CHANGE IN THE WHEEL NUT (M22X1.5) TIGHTENING TORQUE

Picture 1. Wheel nut tightening sequence.

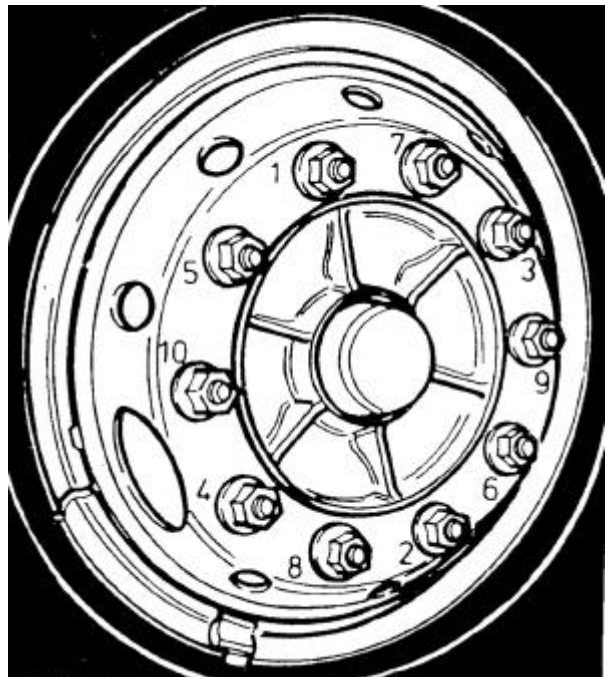
The tightening torque of the wheel nut with M22x1.5 thread has been changed.

According to the new tightening instructions the installing of the wheel nuts have to be done with the threads oiled.

This change is to improve to achieve sufficient pre-load in wheel attaching and also to maintain the preload.

- Inspect that all the nuts and bolts are clean and undamaged.
- Oil the threads and the sliding surface between the nut and its washer lightly.
- Tighten the wheel nuts to 550...650 Nm torque.
- The tightening sequence is shown in picture No. 1.
- Inspect the correct tightening torque at the latest after one day's driving.
